Re: Technical Corrections Review: Aurora One – Master Plan Amendment
Application Number: DA-2241-08
Case Number: 2020-7004-01

This letter is in response to the City of Aurora's comments dated December 12, 2024. Comment responses are shown in *red*. No redline responses are provided with this submission. We look forward to the City's approval this amendment.

**AURORA ONE
PUBLIC IMPROVEMENT PLAN (PIP)
PLANNING AREAS PA-4 EXHIBIT**

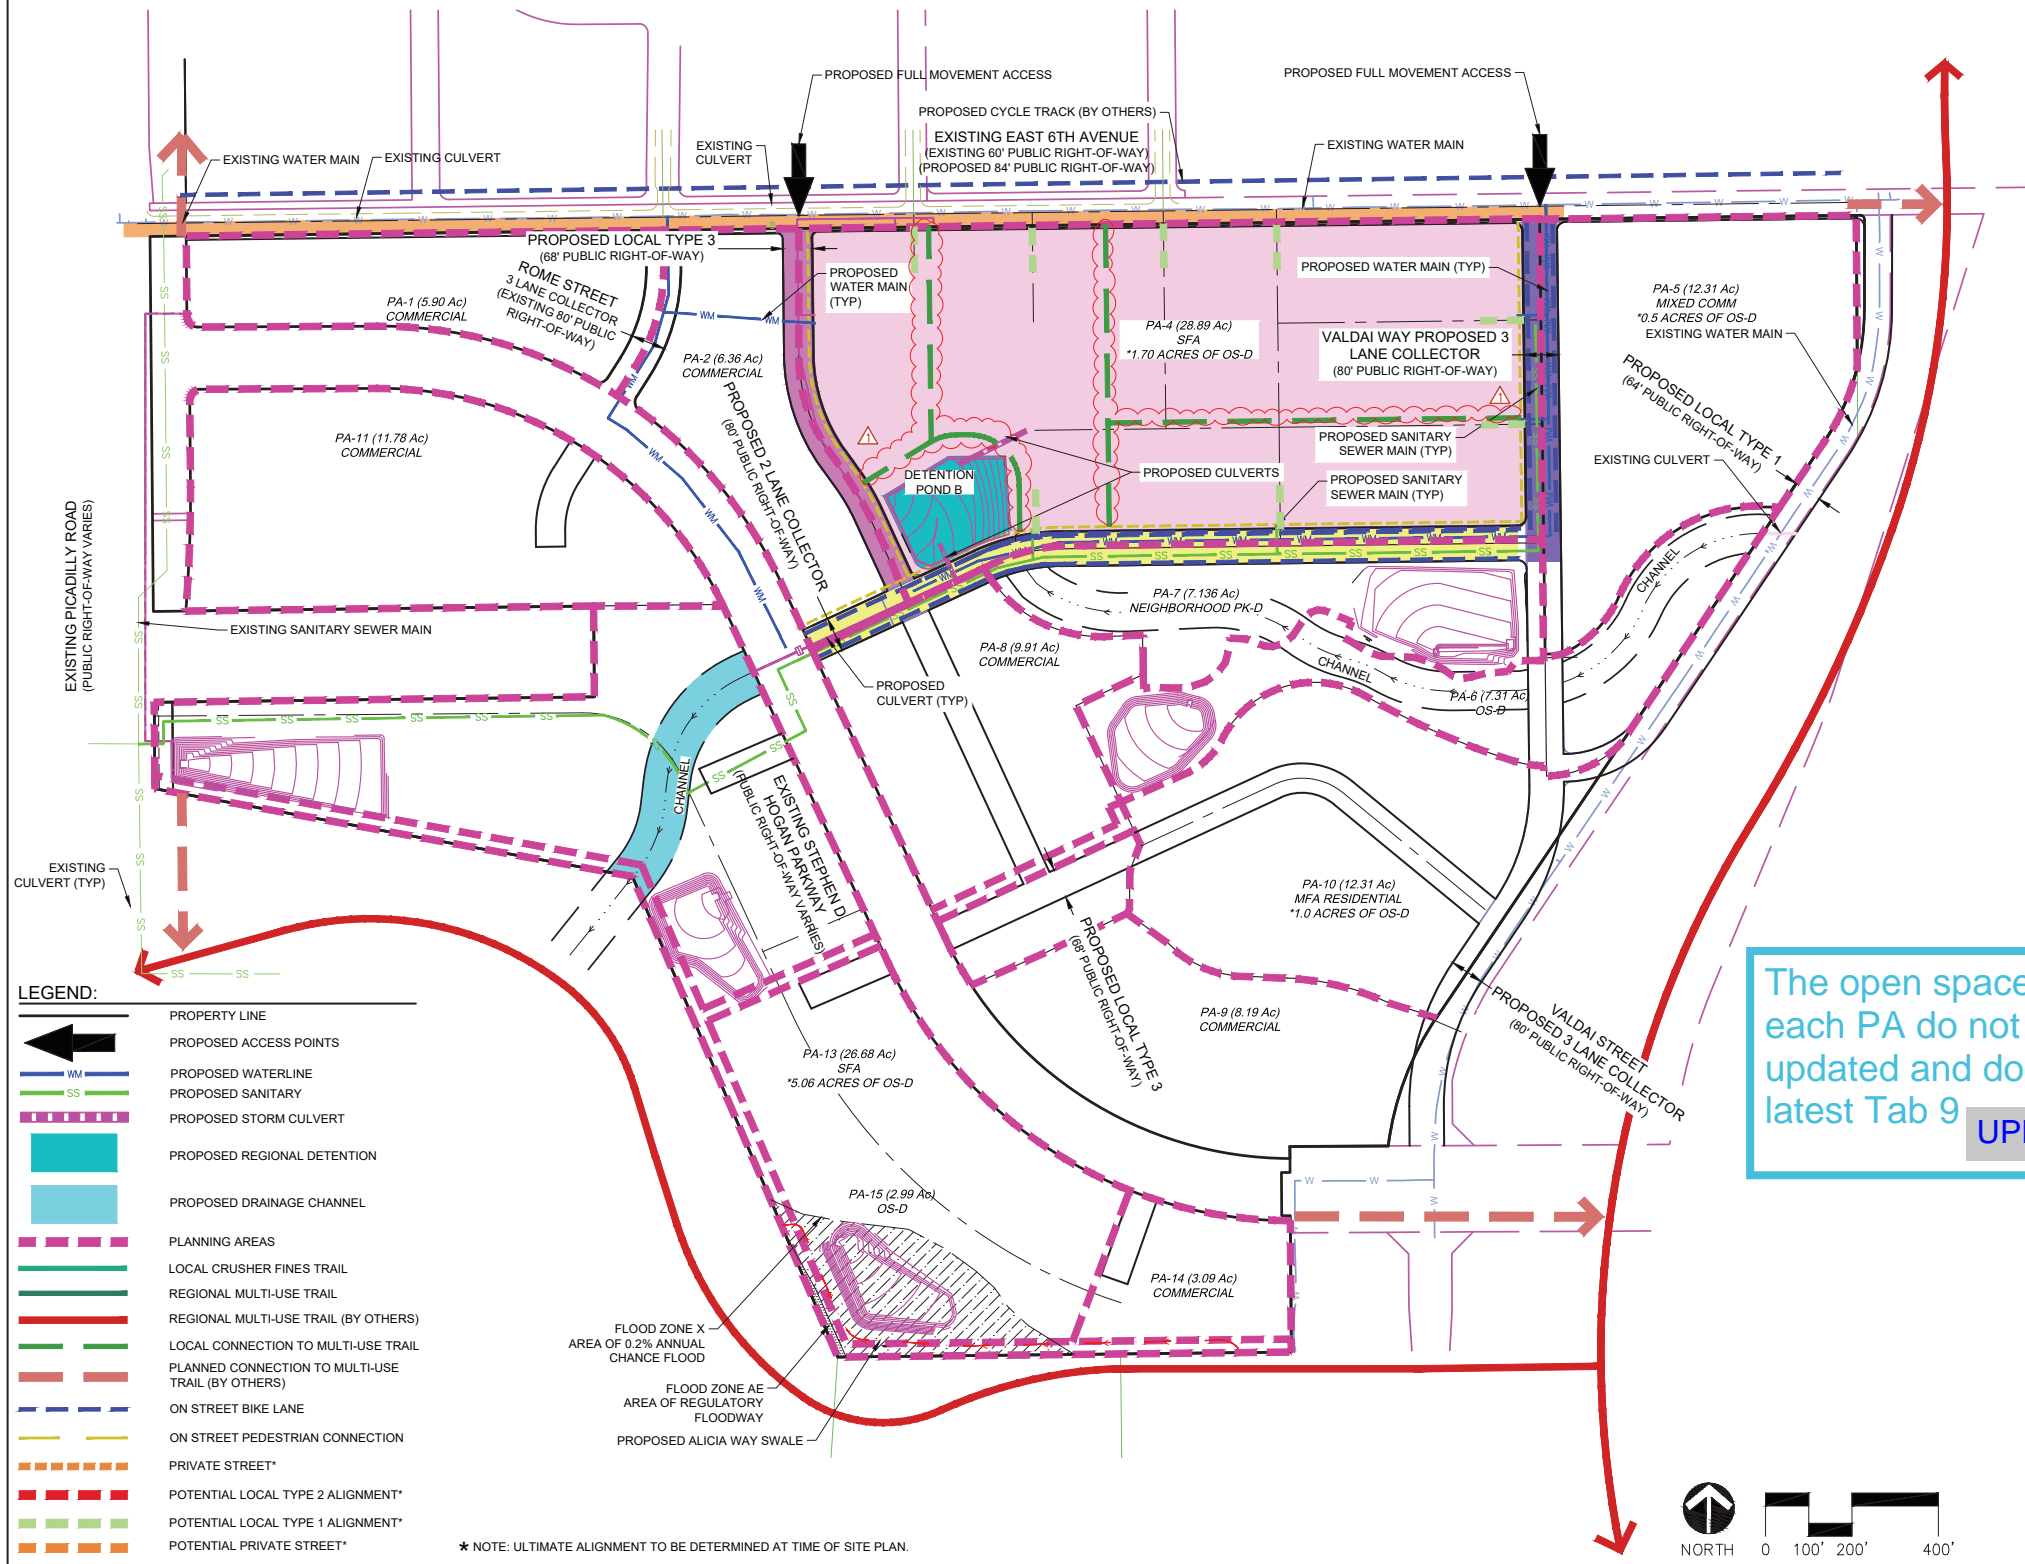
The open space acreages in each PA do not appear to be updated and do not match the latest Tab 9

UPDATED.

**AURORA ONE
PUBLIC IMPROVEMENT PLAN (PIP)
PLANNING AREAS PA-10 EXHIBIT**

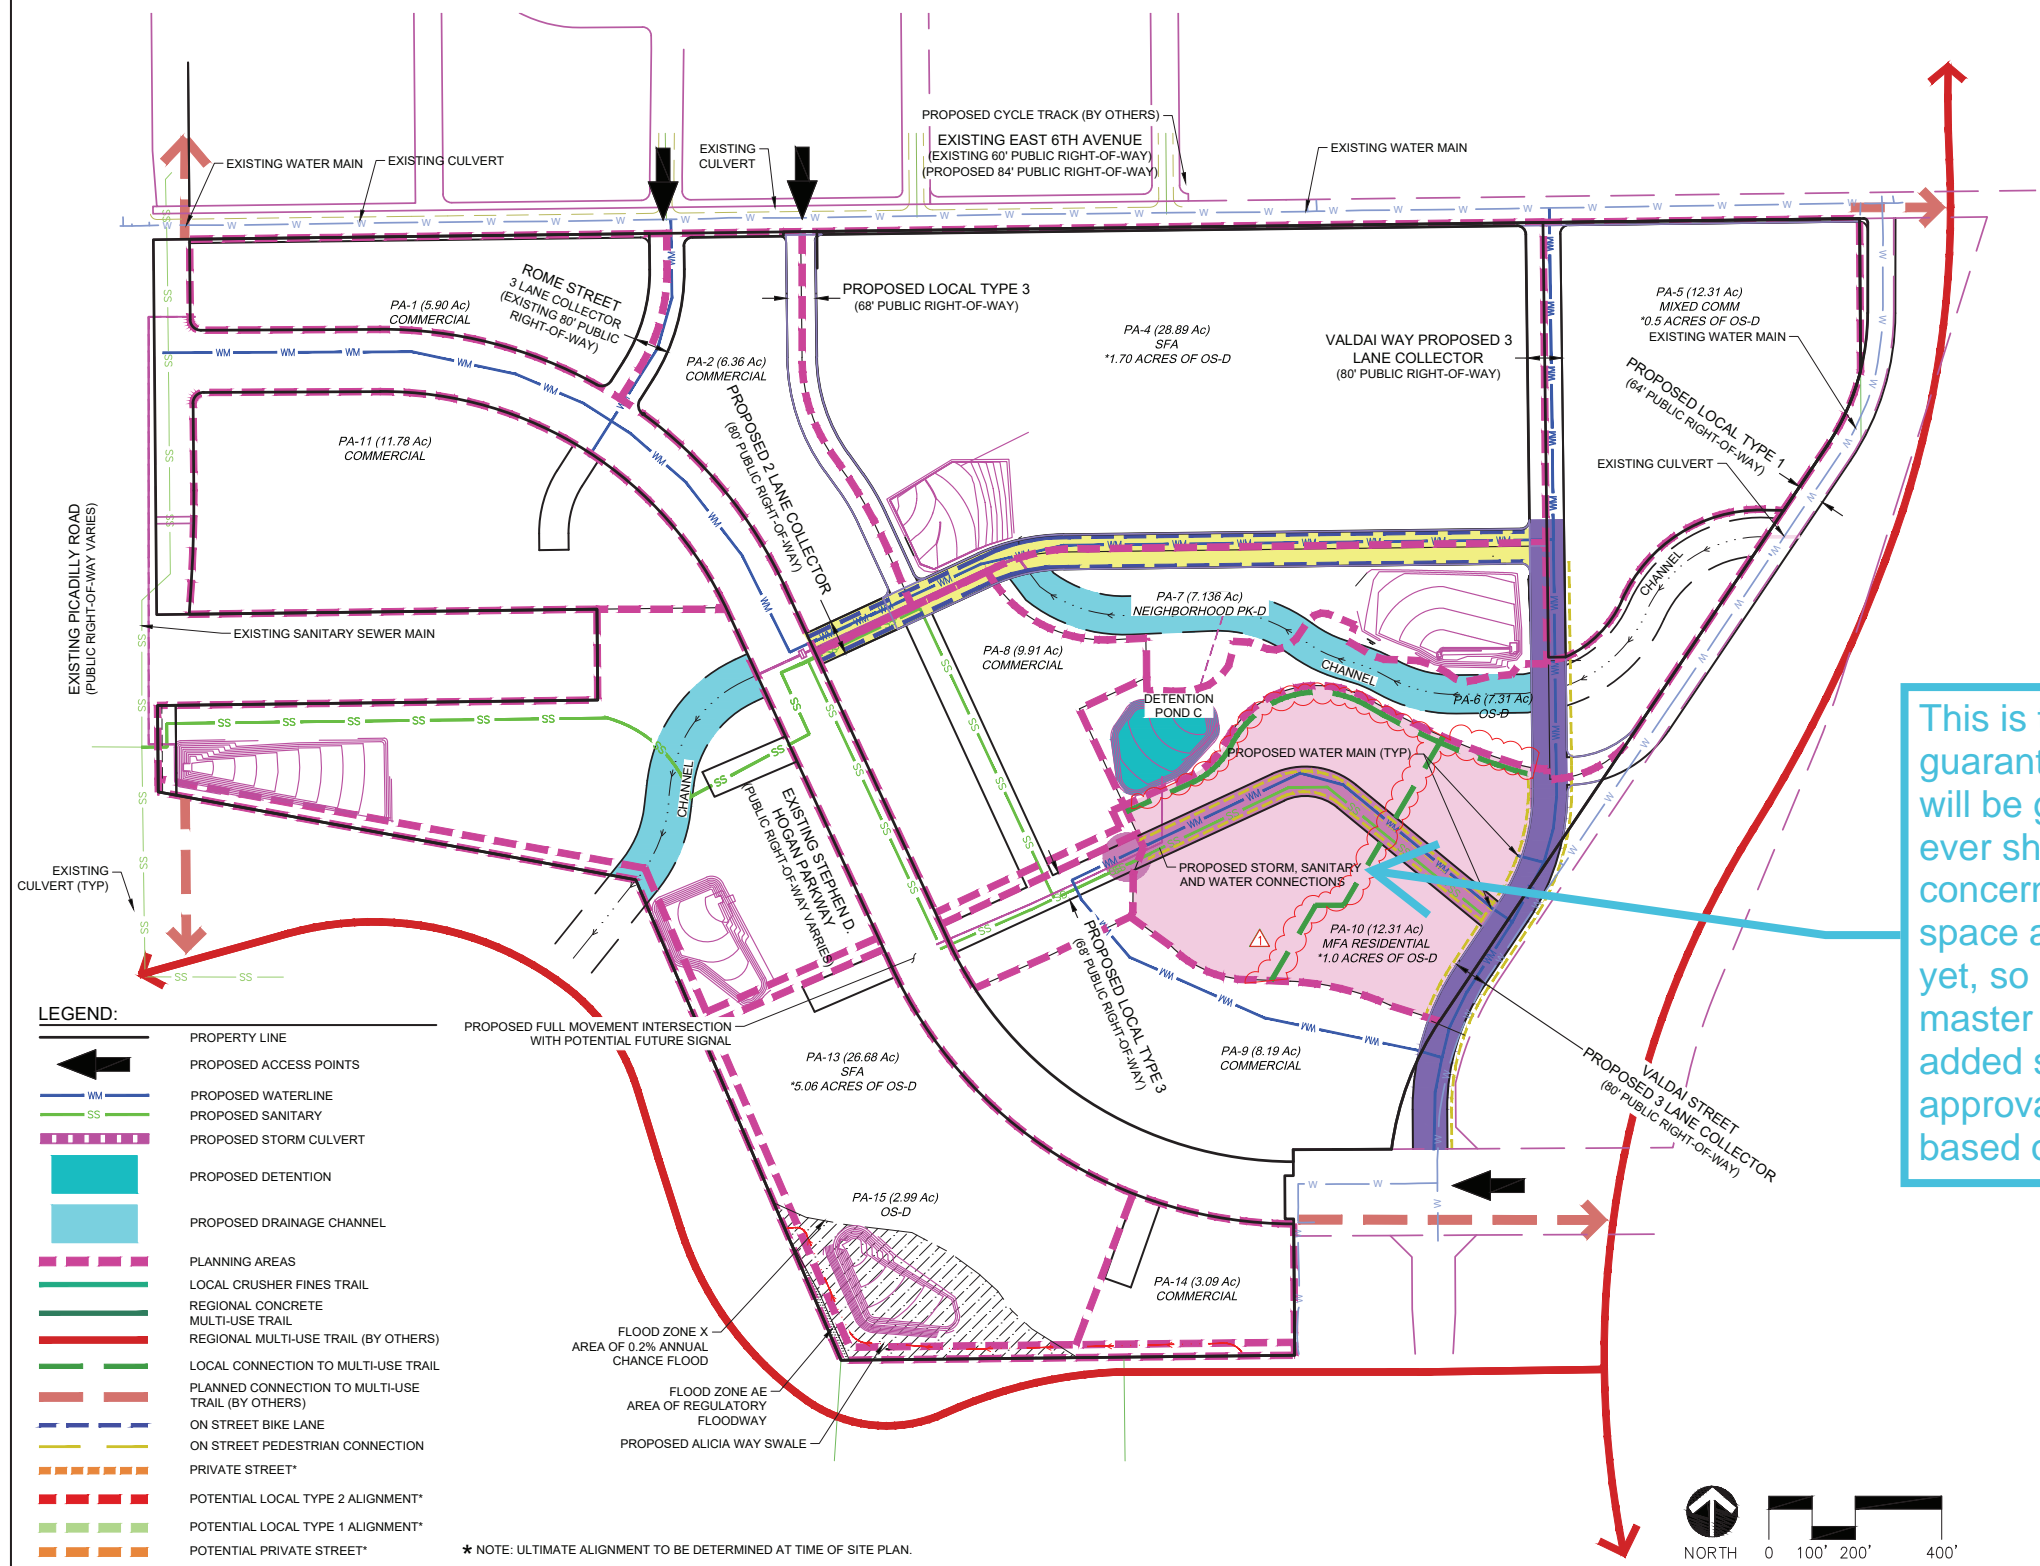
This is too specific and it cannot be guaranteed that open space credit will be granted here. Nothing was ever shown to staff that resolved our concerns with counting this as open space and it hasn't been agreed to yet, so it shouldn't be depicted in the master plan, or a note needs to be added stating that it is subject to approval at the site plan stage based on the design.

NOTE ADDED.
